Name	Signature			Date
Application made by:					
Location (Sector/Site Name):	Euston Station				
LAA/LAP/Site Reference	S311_053				
Work Package number:	N/A				
Date of Tree Panel:	22/07/25				
Site Description:	Euston Square Gardens west, Euston				
Reason for clearance:	Pruning of 3 trees that are impacting the passage of buses, taxis and people respectively				
Drawing Reference No.:	N/A				
	Yes	No	N/A	Comments	
Has the Stage 1 Survey been completed and logged on the Register	Y				
	Yes	No	N/A	Comments	
Has the Stage 2 Survey been completed with retention and protection measures logged on the Register	Y				
Have all practicable means to negate need for works to tree been investigated? Please provide details	This is regular maintenance pruning to ensure that tree branches are not damaged by cars and buses.

T031

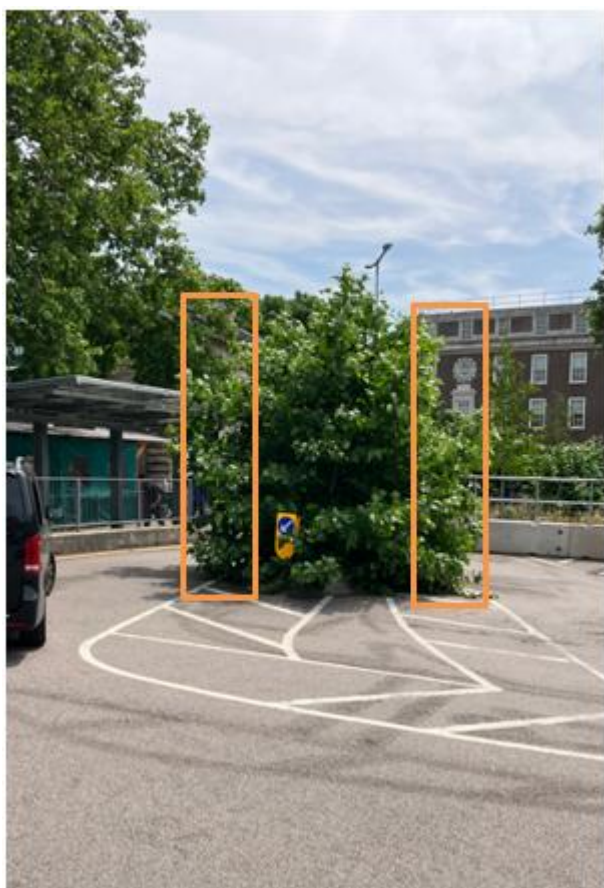
Proposal Endorsed/Not Endorsed:	To28 and To36 are endorsed. To31 not endorsed
Conditions	To36: MDjv to keep pruning to a minimum and set up a regular maintenance regime To31: AS and PL to visit the tree and feedback on whether or not to prune
